RE: OUTLOOK AT NINE MILE DRAINAGE REVIEW

We have reviewed the Outlook at Nine Mile submittal received on February 10, 2020. The submittal included a Phase III Drainage Report for Outlook Nine Mile, Construction Plans for Outlook at Nine Mile, and a Site Plan for Outlook at Nine Mile all revised January 27, 2020, by Harris Kocher Smith. The resubmittal also included a response to comments letter from Norris Design, dated January 31, 2020. We have the following comments to offer:

Subject: Nine Mile Corner - Site Plan SP-000832-2016

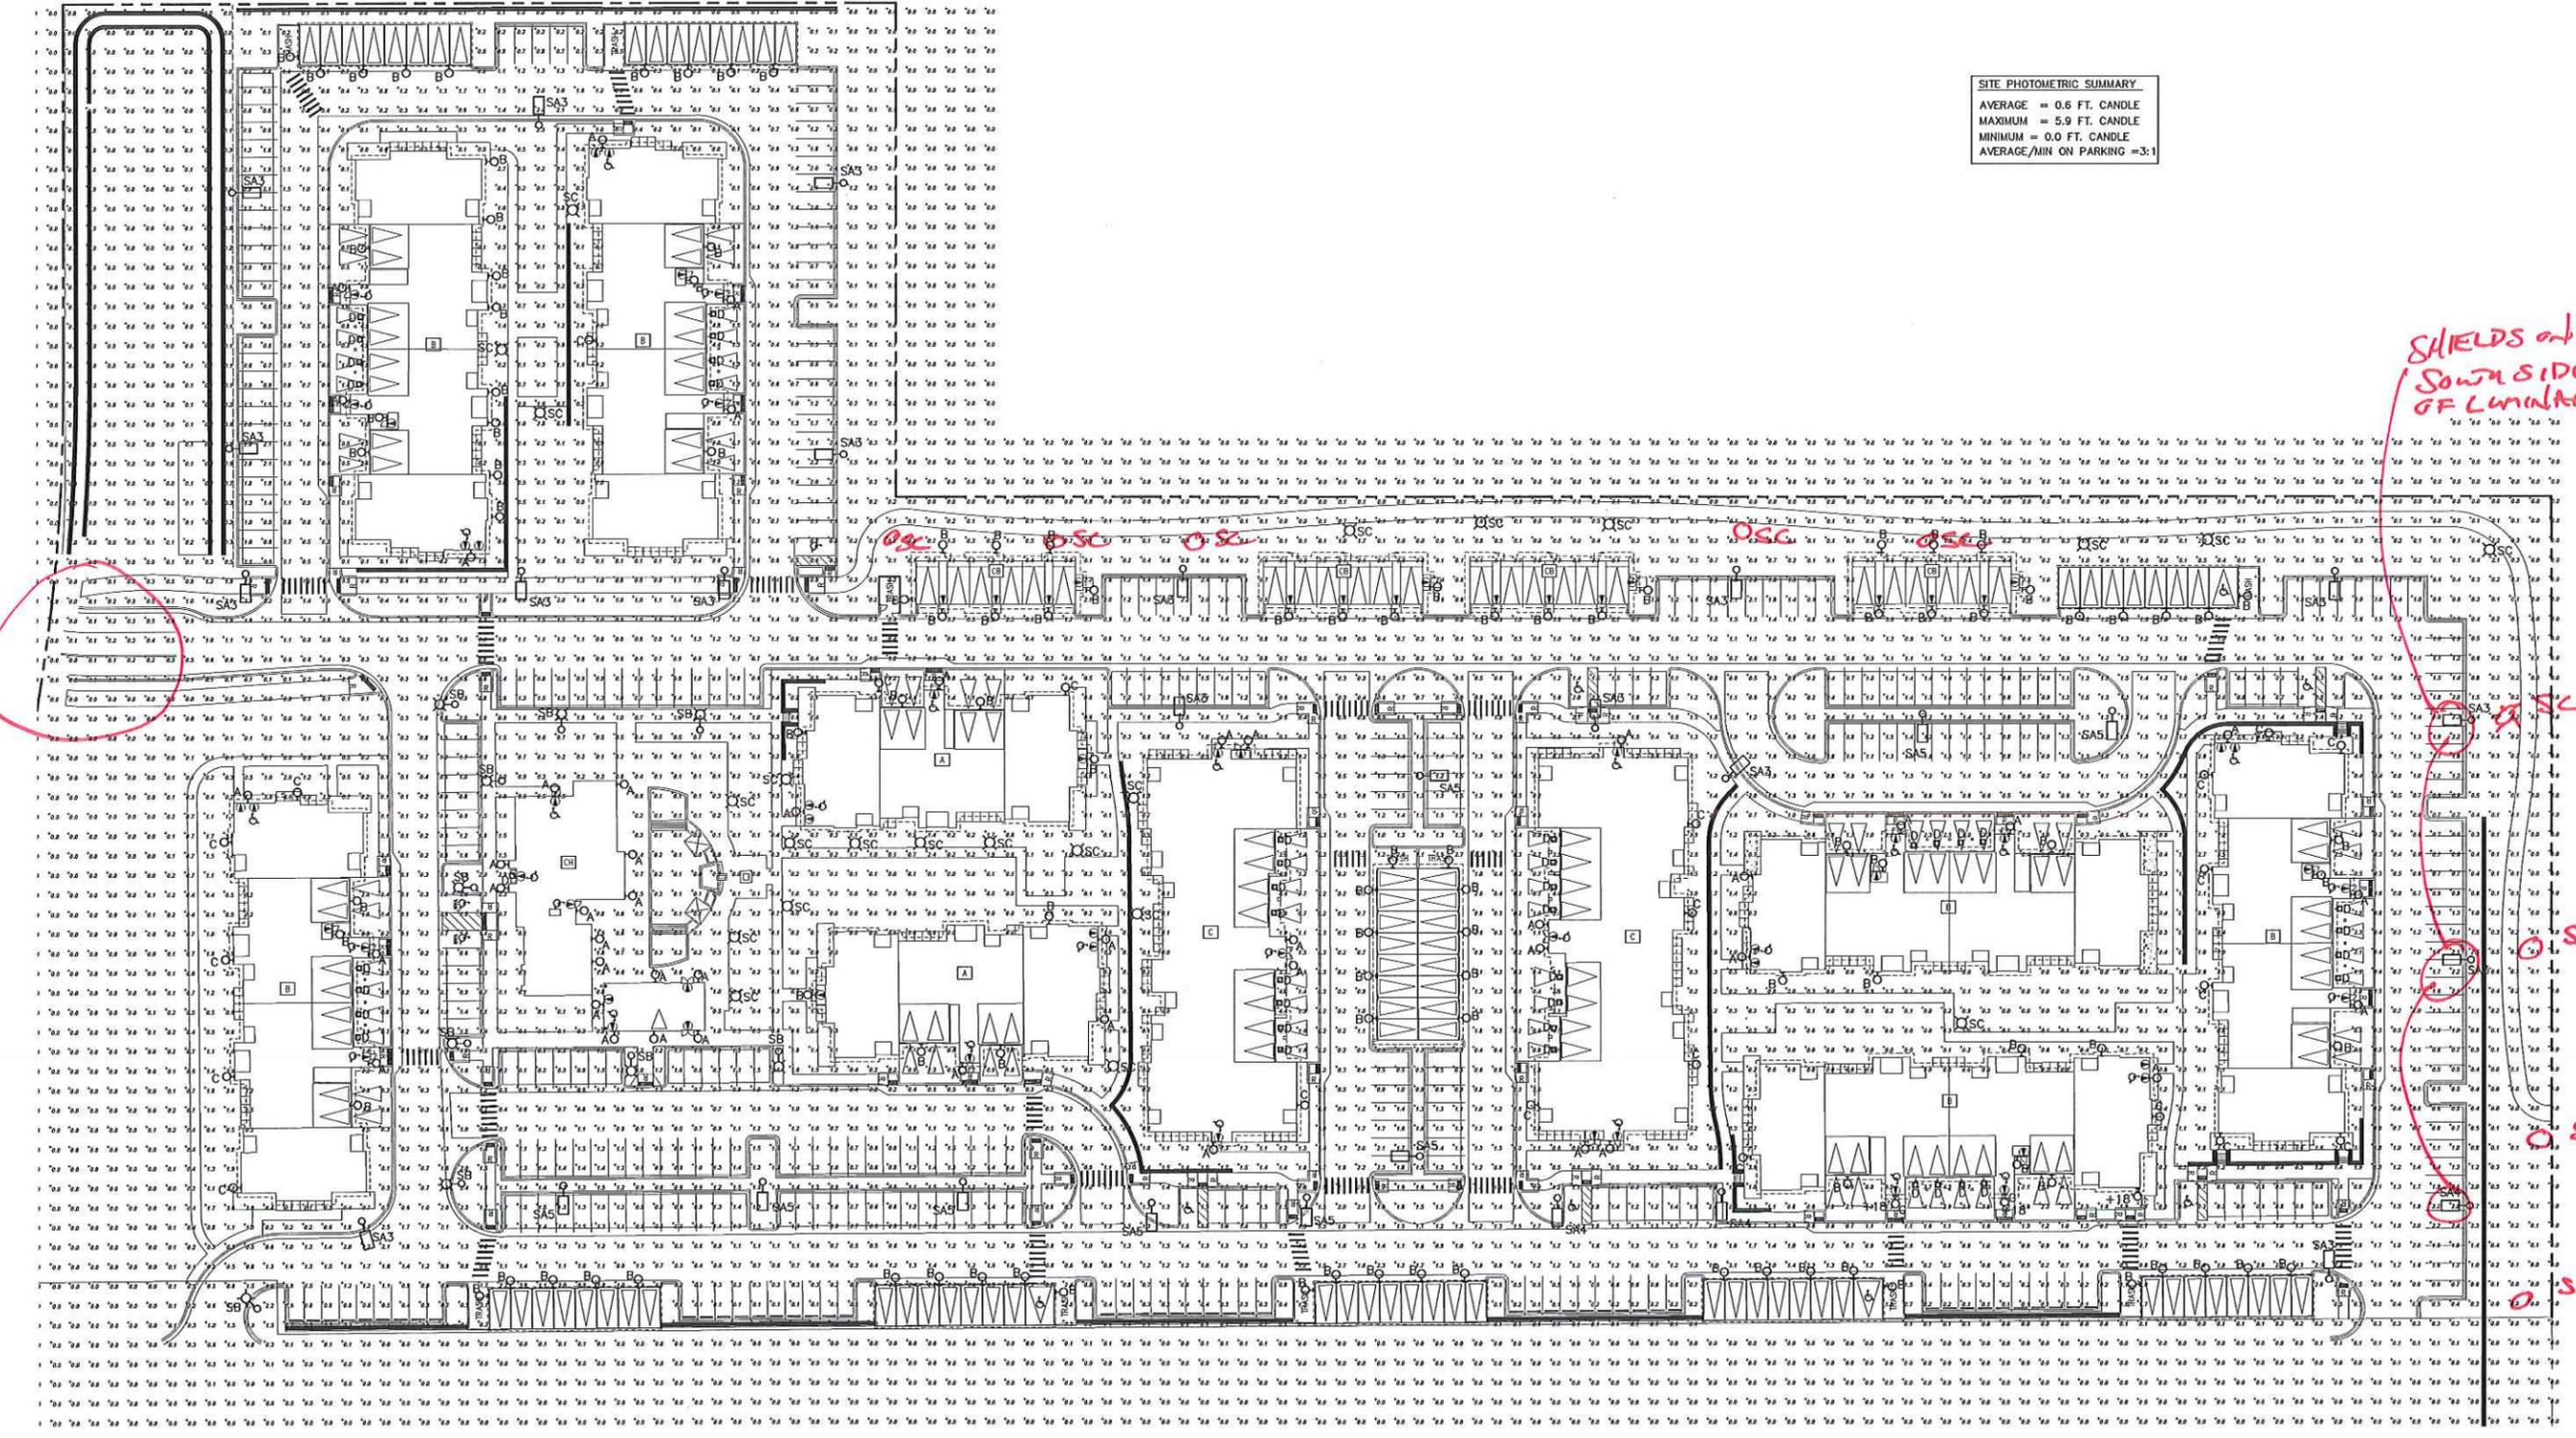
LIGHTING?

SHIELDS on
SOUTH SIDE
OF LUMINA
